# CITY OF ALBUQUERQUE

**RE: Ramsey, Janel – Garage Addition**  
**6009 Mesquite Dr NE – (ABQ-PLAN Address: 6009 Camino Placido NE)**  
**Grading and Drainage Plan**  
**Engineer's Stamp Date: 9/2/25**  
**Hydrology File: E19D035**  
**Case # HYDR-2025-00318**

RAMSEY GARAGE ADDITION – GRADING & DRAINAGE PLAN

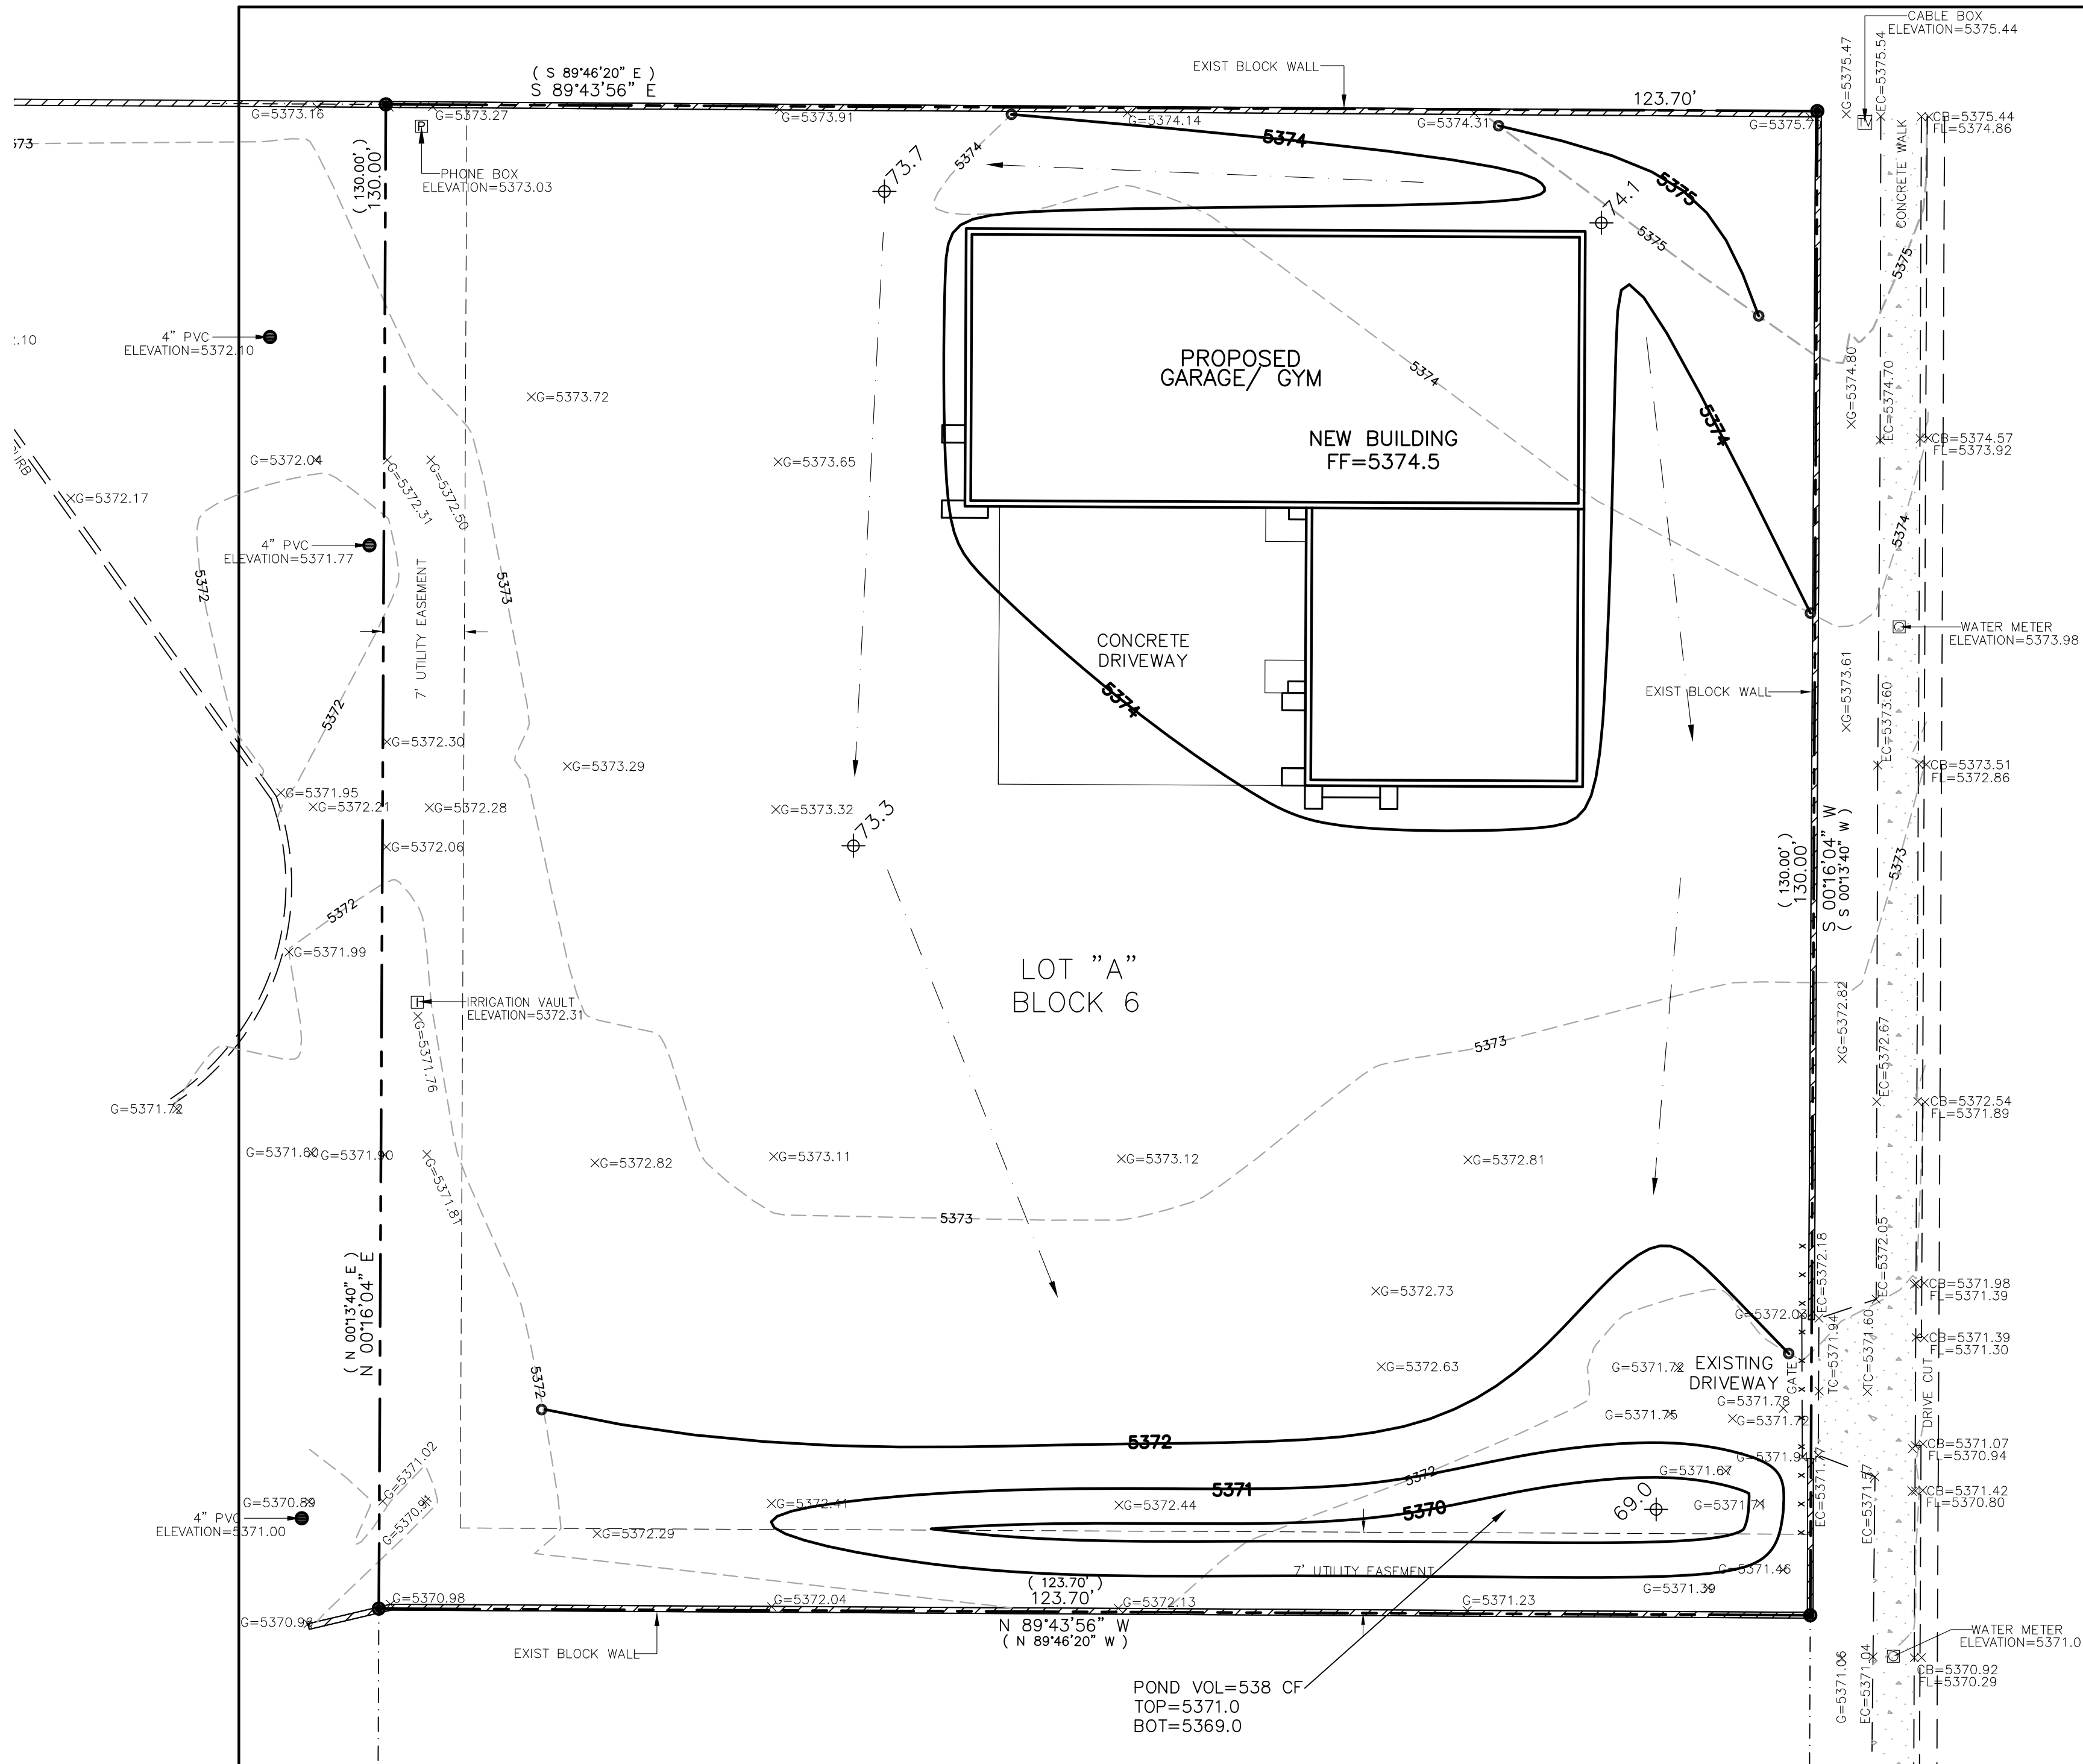
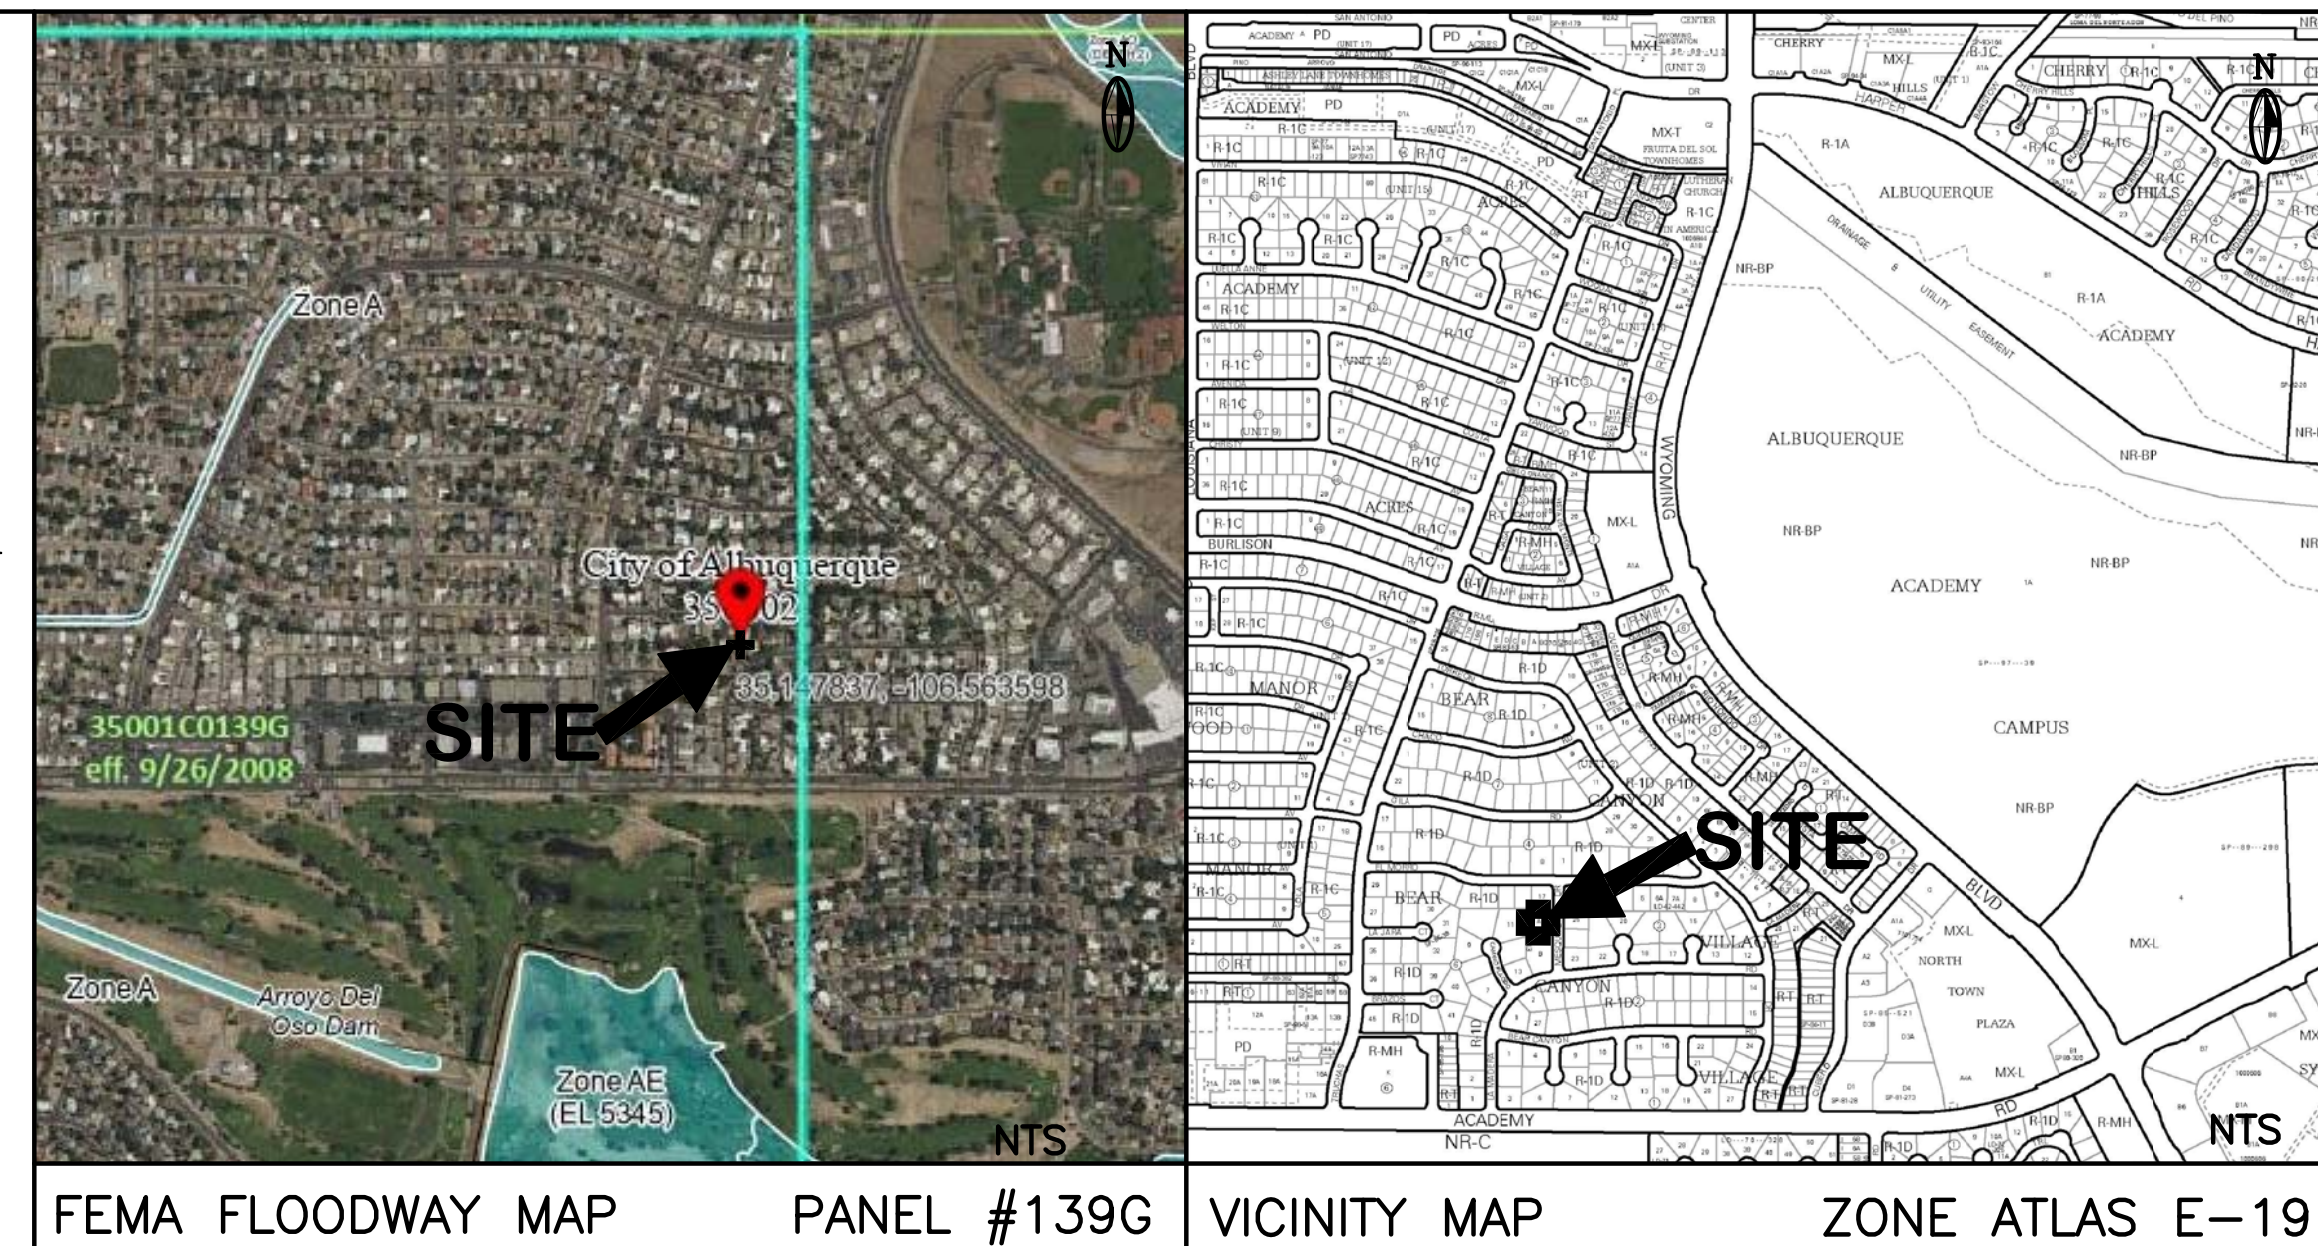
Based upon the information provided in your submittal received 9/2/2025, the Grading & Drainage Plan is approved for Grading Permit and Building Permit. Please attach a copy of this approved plan in the construction sets for Building Permit processing along with a copy of this letter.

1. Engineer's Certification, per the DPM Part 6-14 (F): *Engineer's Certification Checklist For Non-Subdivision* is required.
